265 South Wetherly Drive

STAFF REPORT
CITY OF BEVERLY HILLS

**For the Design Review Commission
Meeting of March 4, 2010**

SUBJECT: A request for an R-1 Design Review Permit to allow a new two-story single-family residence located in the Central Area of the City, south of Santa Monica Boulevard at **265 South Wetherly Drive.** (PL 100 0935)

Proposed 2/4/10

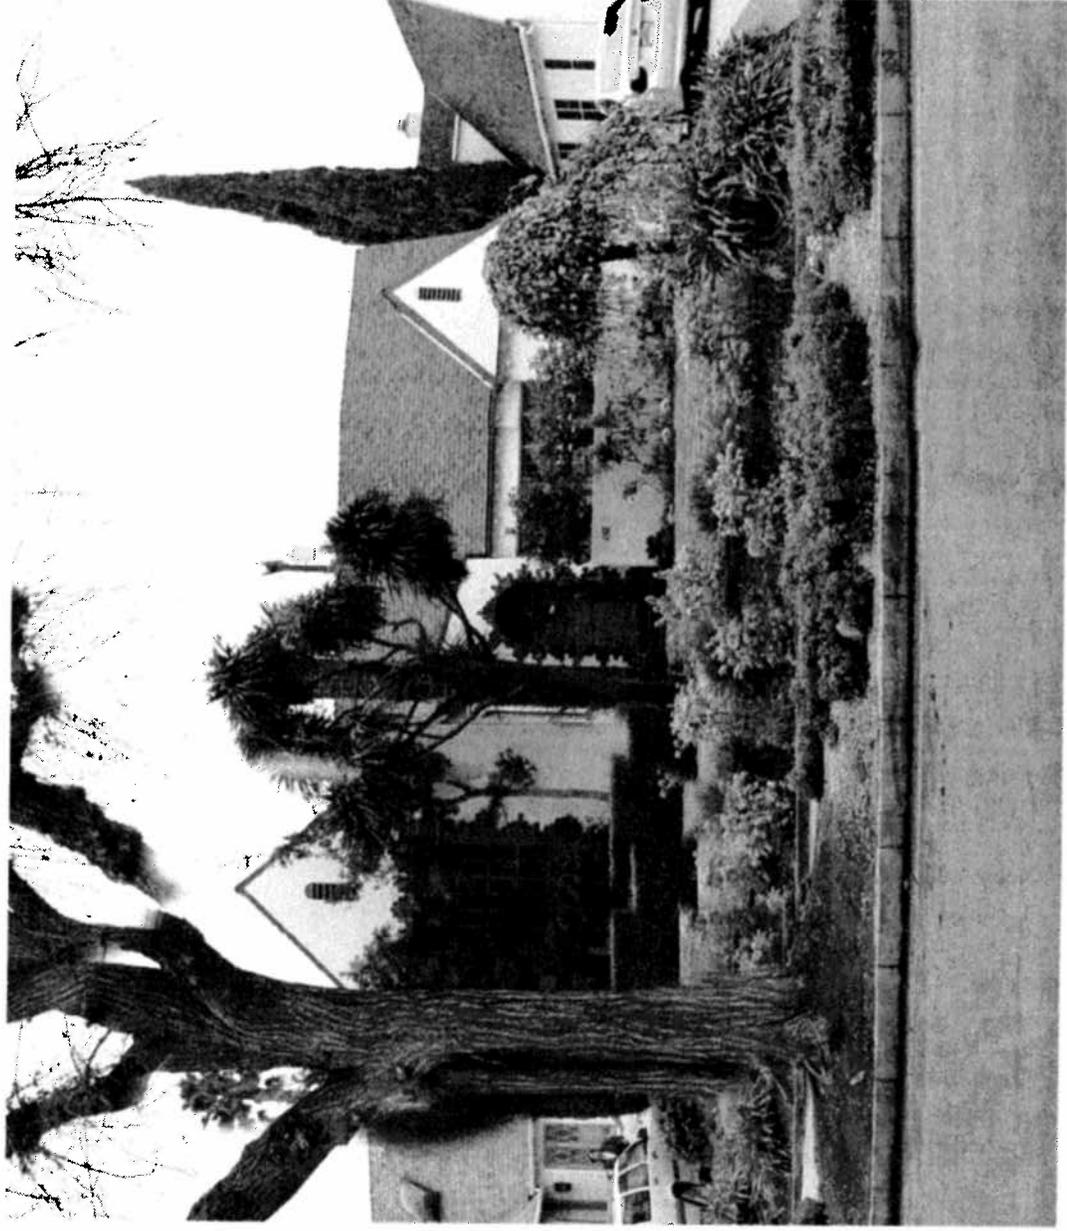
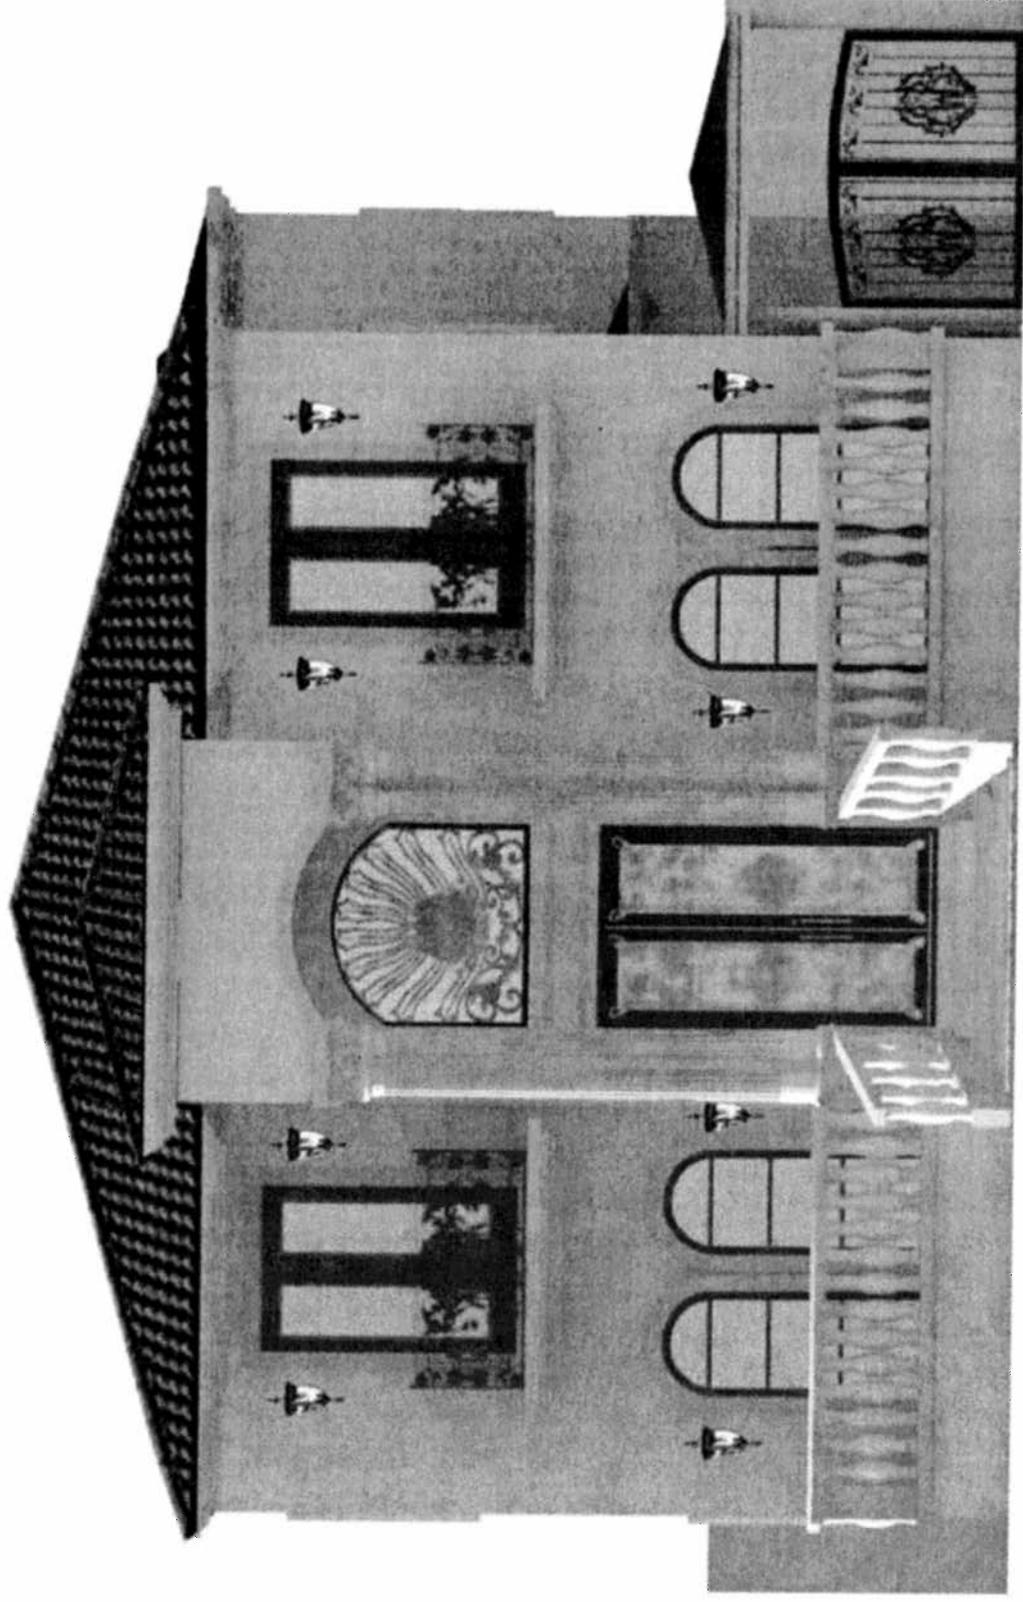
Staff does not feel that the project meets the 5 criteria (attached as Attachment B) required for approval in that this design. Although the revised design is more consistent with the Italianate style of Architecture, Staff has concerns with the abundance of the architectural details and mass and scale of the design elements. The Commission may wish to discuss the elaborate nature of the wrought iron details at the front door and the scale and massing of the design.
